**CARL GOLDBERG PRODUCTS, LTD.**

## ***SOPHISTICATED LADY*** **PRODUCT IMPROVEMENT NOTICE**

### ***Rudder Control Installation***

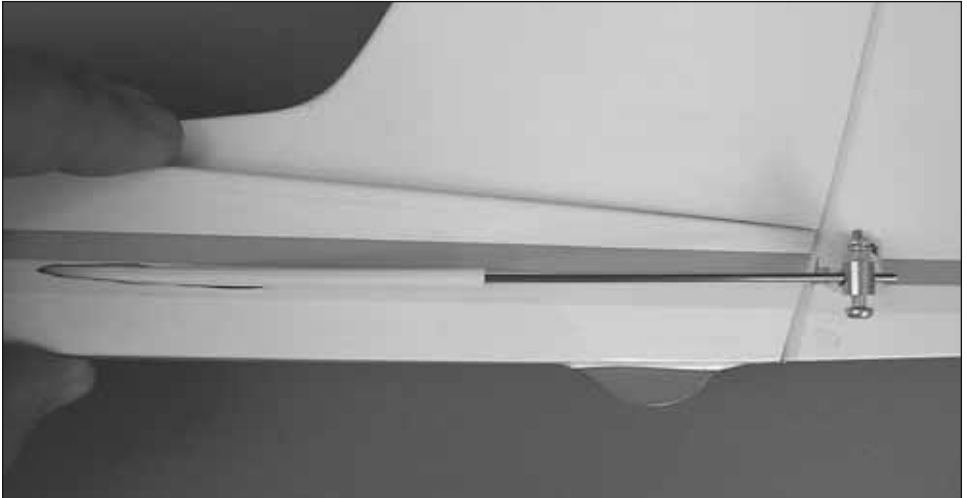
1. Please use the included 1/16x36" pushrod with 24-1/4x1/8" pushrod tube in place of the 10" threaded wire, 4" wire with wooden dowel, and two pieces of shrink tubing mentioned on page 8, step 8. The included 27-1/2" flex cable with 24-1/4" tube is no longer needed.

2. Install the pushrod with tube through the fuse by first entering the guide hole and then exiting the fuse through the provided hole under the covering. Once the tube protrudes 1-1/2" from the hole in the fuse CA into place. Remember to also add CA to the tube where it enters the guide hole in the wing saddle former.

3. Use the included brass pushrod connector to attach the 1/16x36" pushrod to the rudder control horn.

4. Trim the 1/16x36" pushrod and 24-1/4x1/8" tube to fit at the servo and install the pushrod to the brass pushrod connector on the servo arm.
